WAURN PONDS RESIDENCE

TOWN PLANNING
165 WAURN PONDS DRIVE, WAURN PONDS

REVISION NOTES

GROUND FLOOR PLAN
1:50, 1:100
REFER TO DRAWING
4/08/2026
ISSUE DATE
DRAWN BY

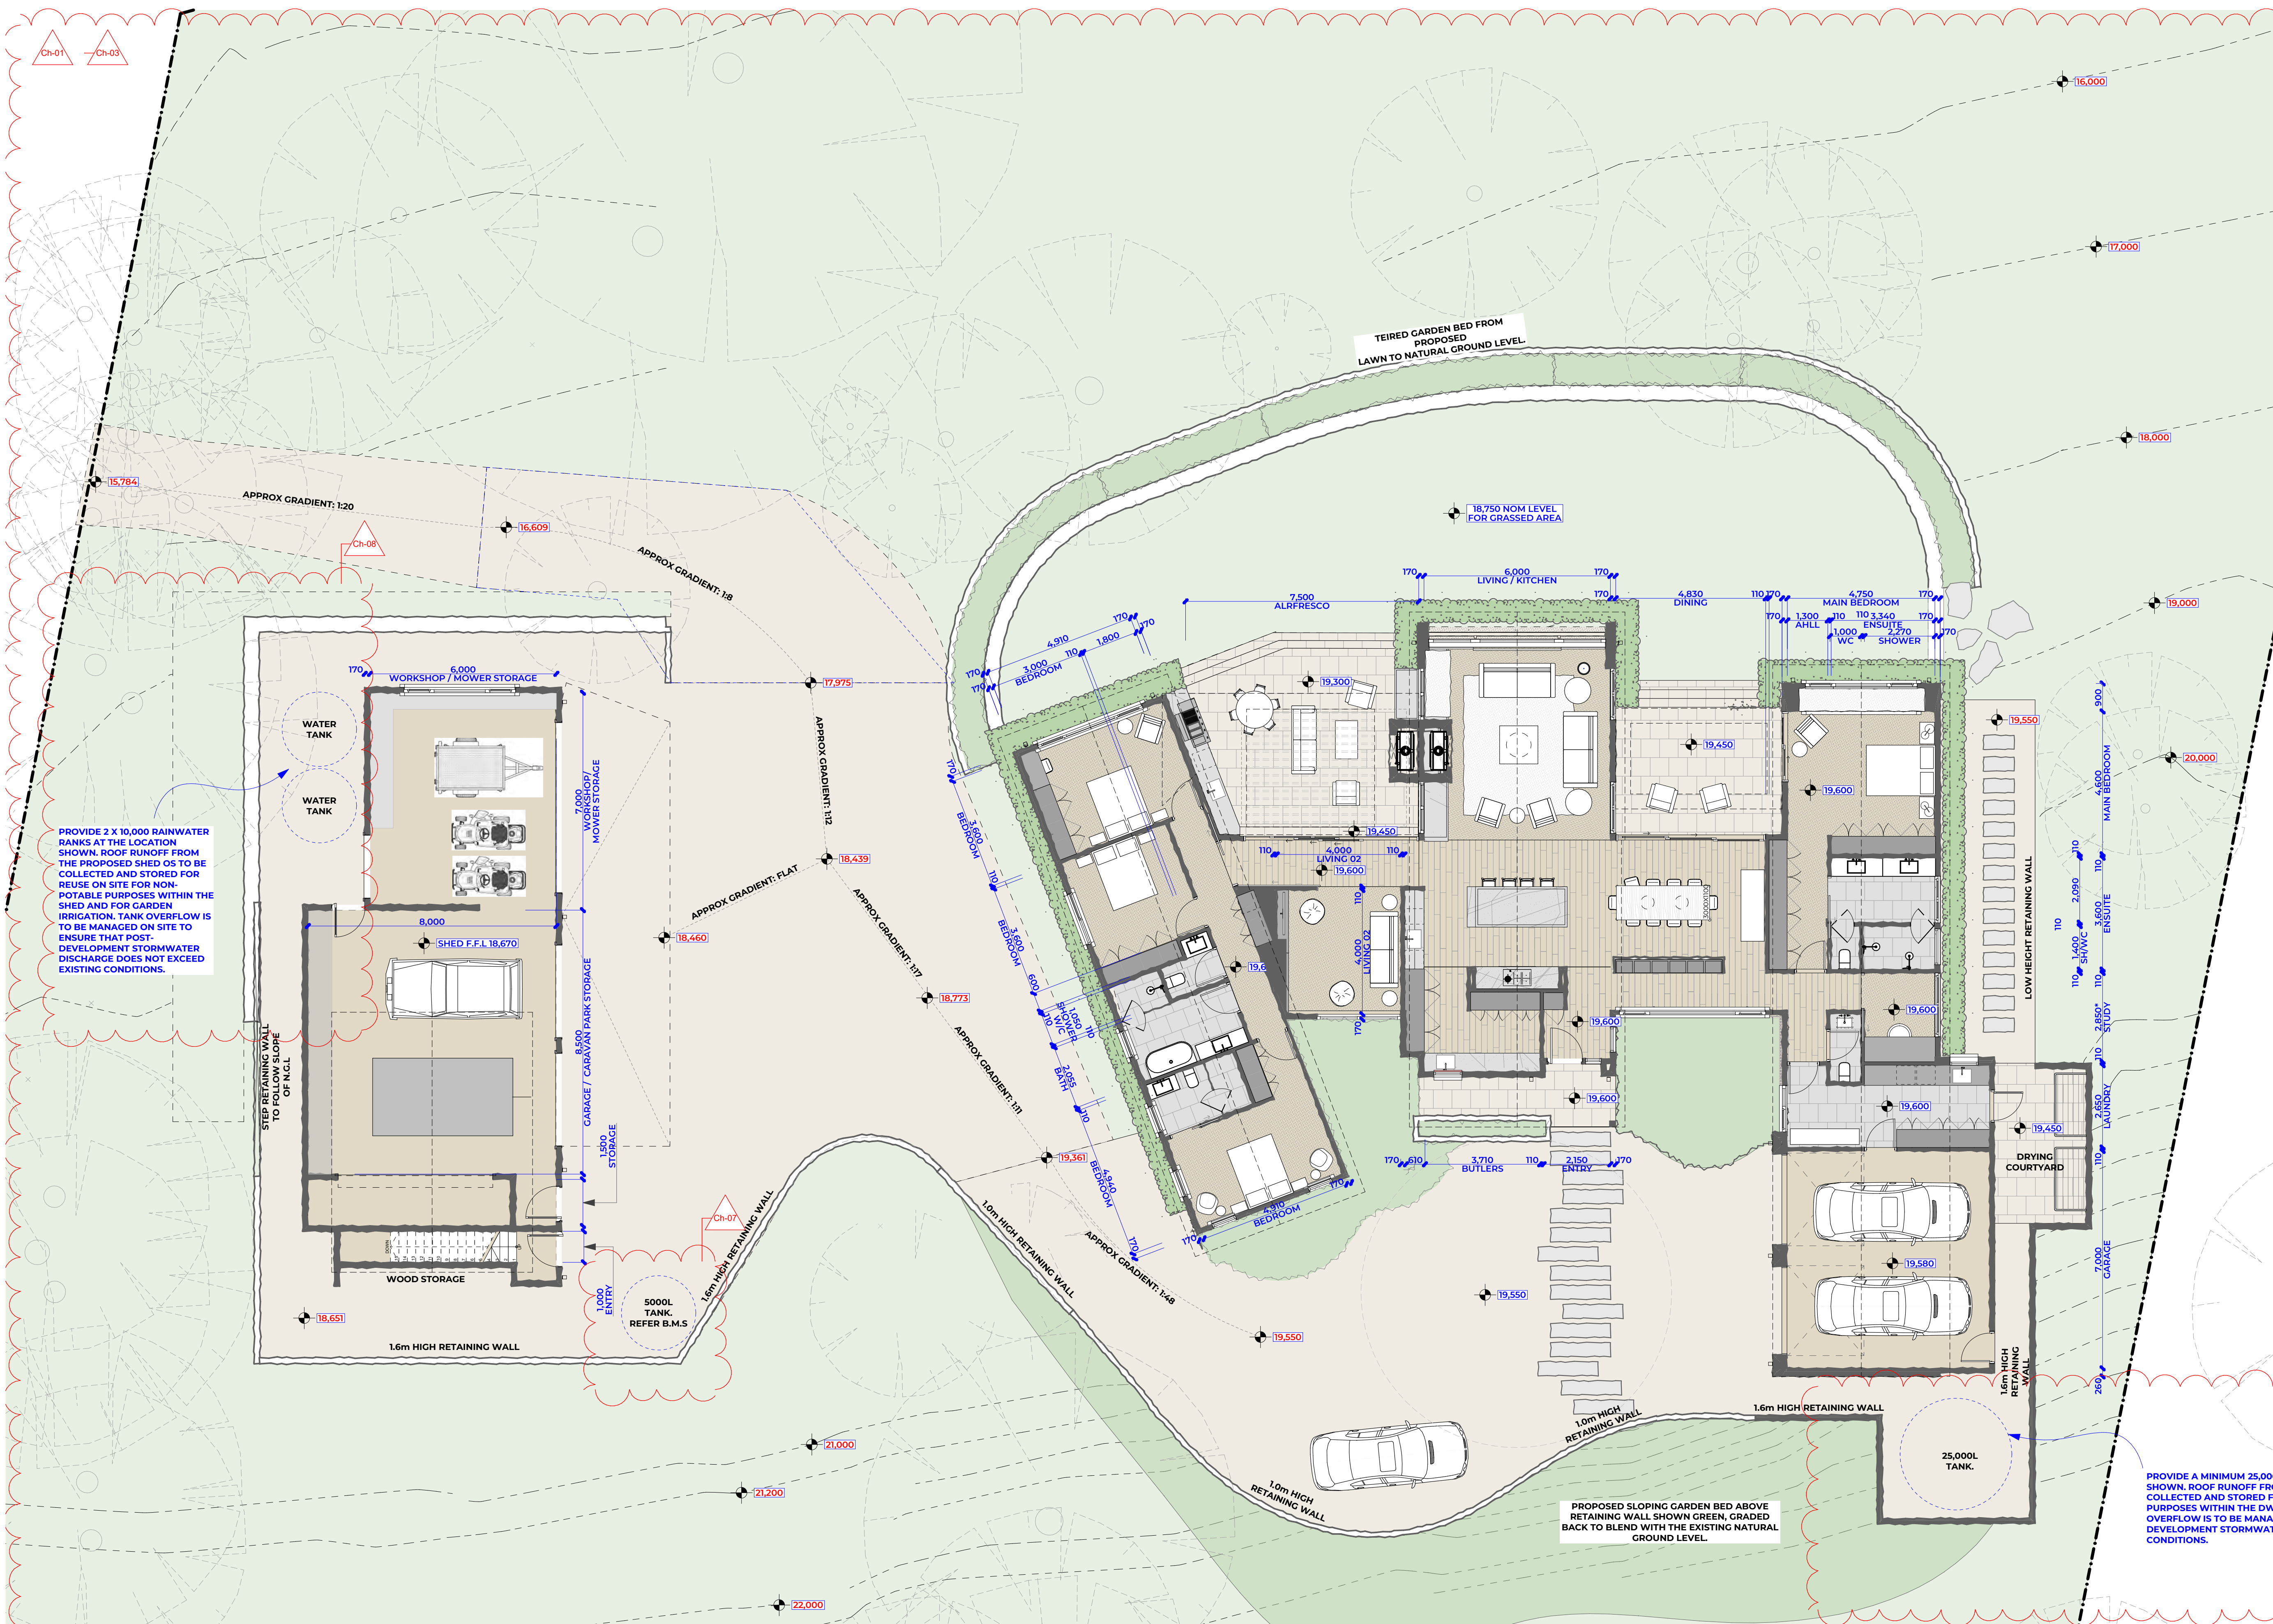
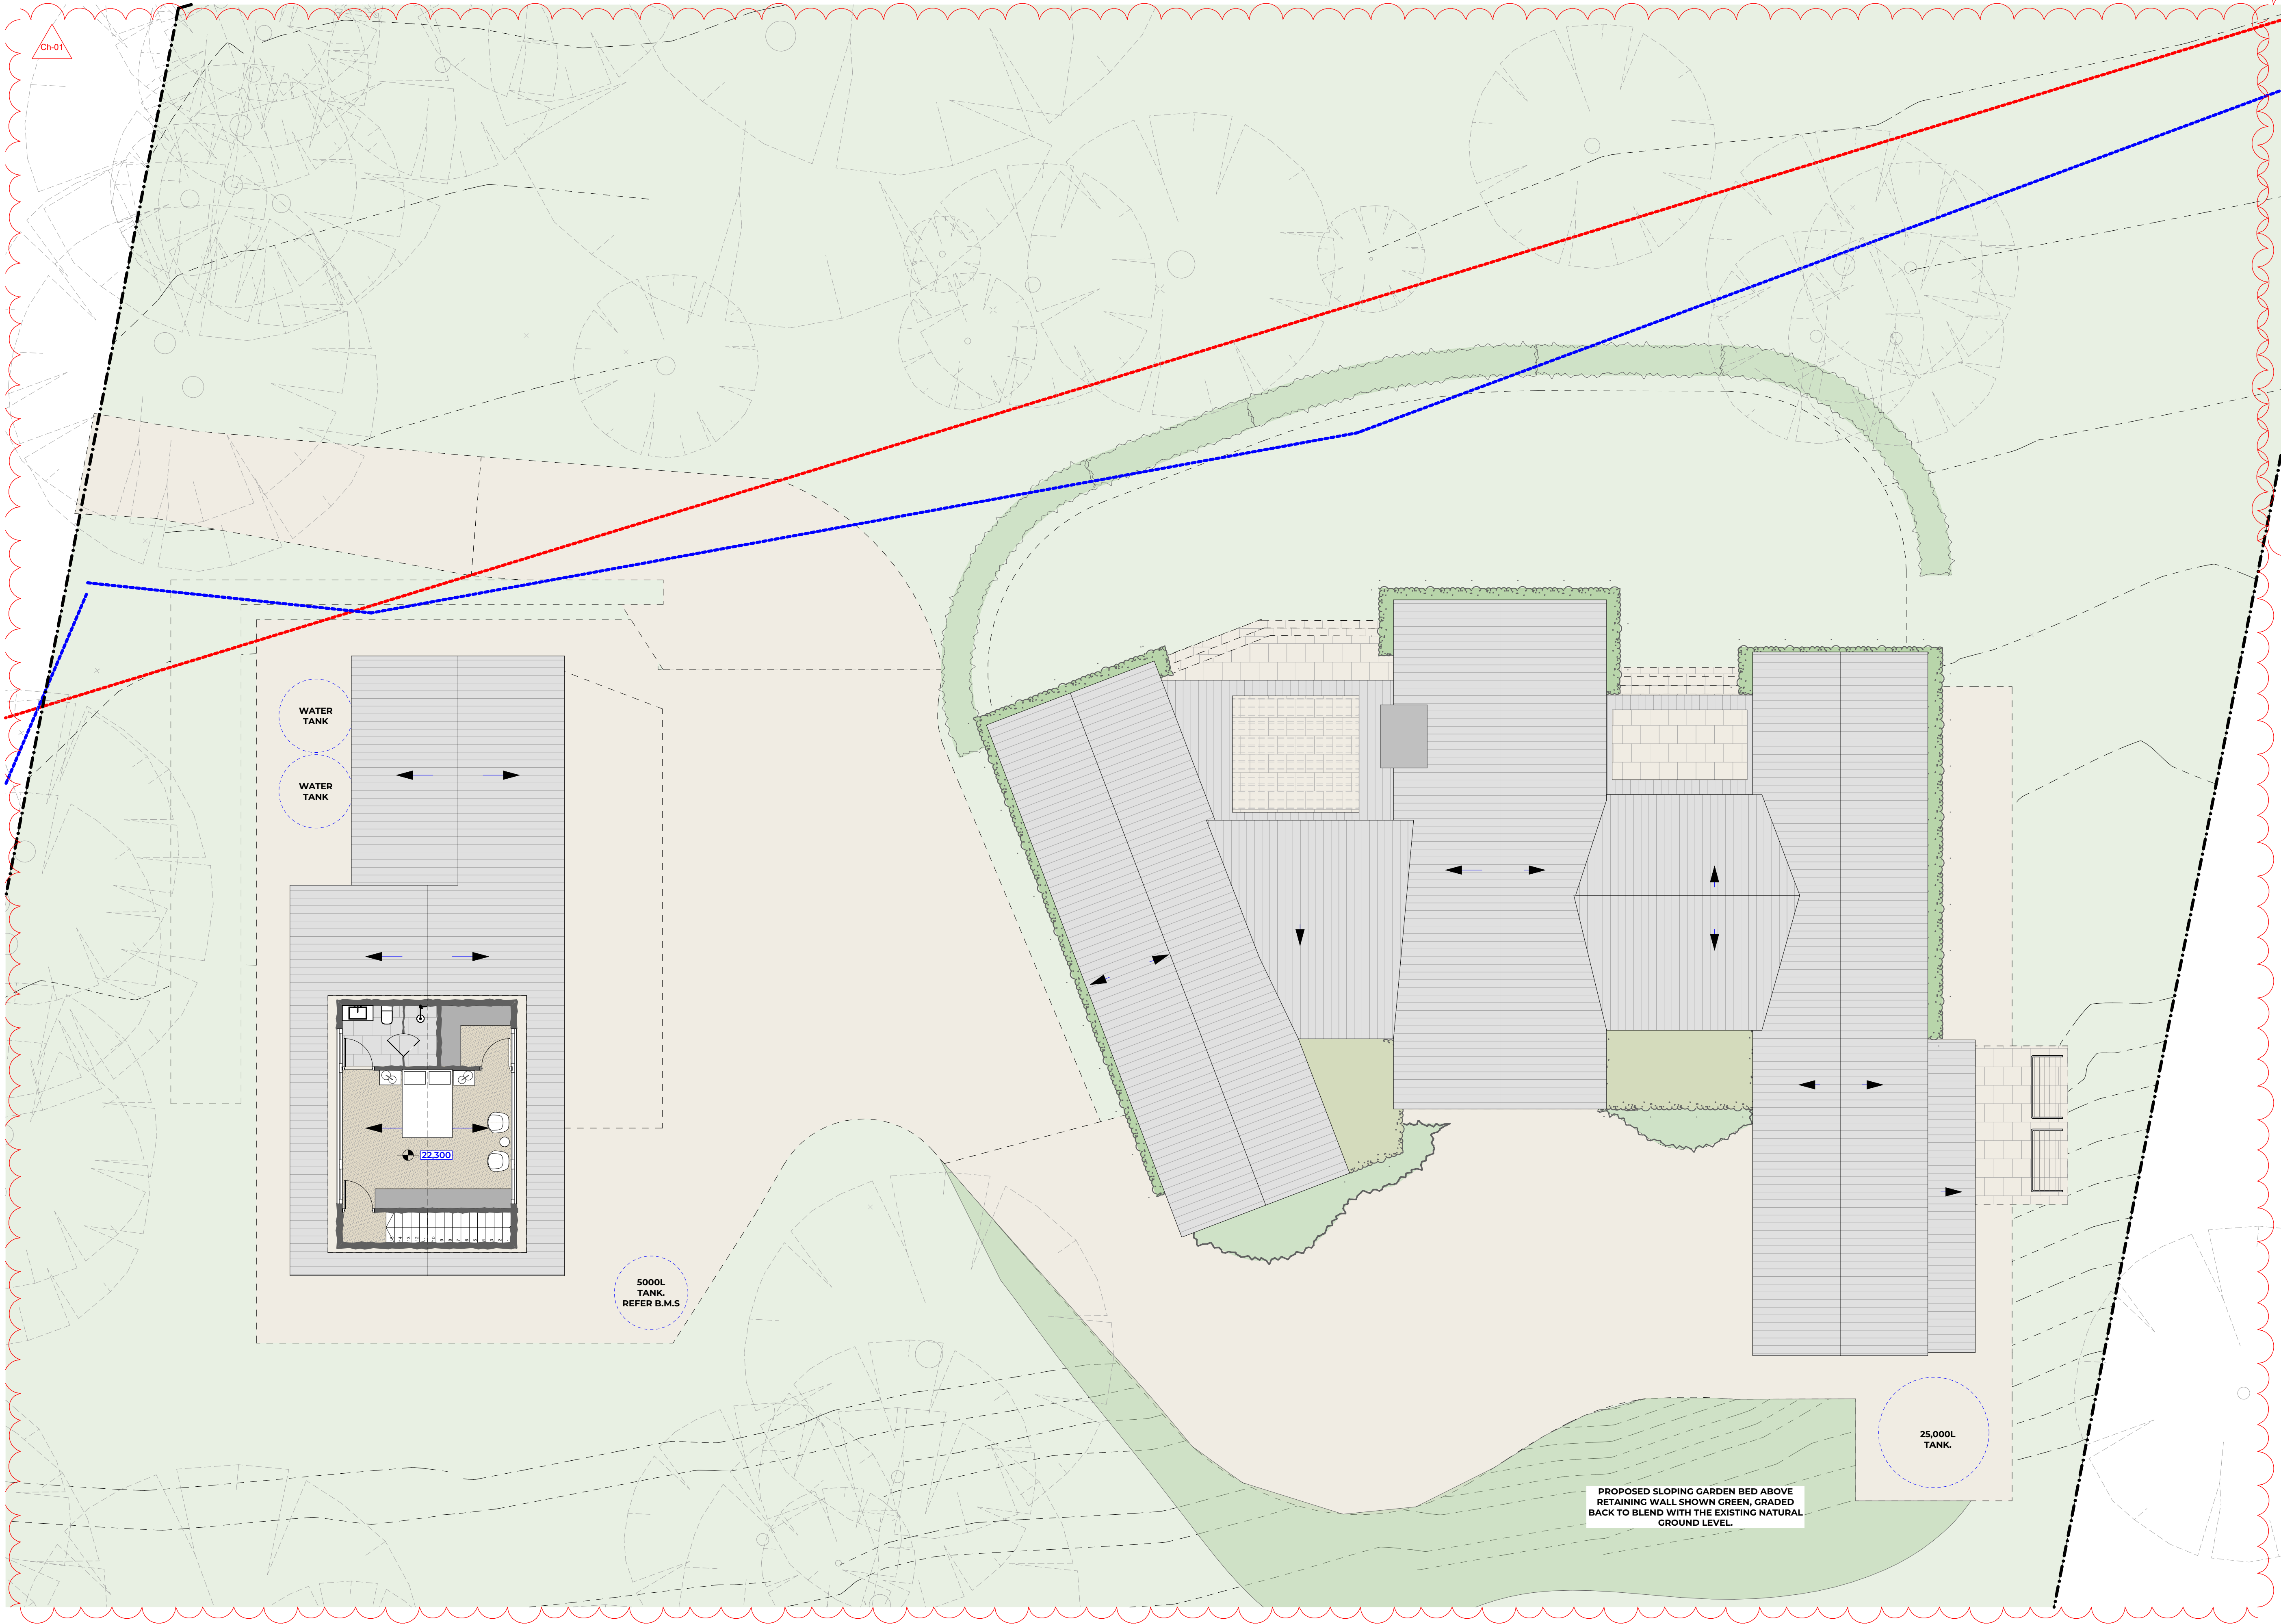
Ch-04

Ch-08

PROVIDE A MINIMUM 25,000 L RAINWATER TANK AT THE LOCATION SHOWN. ROOF RUNOFF FROM THE PROPOSED DEVELOPMENT IS TO BE COLLECTED AND STORED FOR REUSE ON SITE FOR NON-POTABLE PURPOSES WITHIN THE DWELLING AND FOR GARDEN IRRIGATION. TANK OVERFLOW IS TO BE MANAGED ON SITE TO ENSURE THAT POST-DEVELOPMENT STORMWATER DISCHARGE DOES NOT EXCEED EXISTING CONDITIONS.
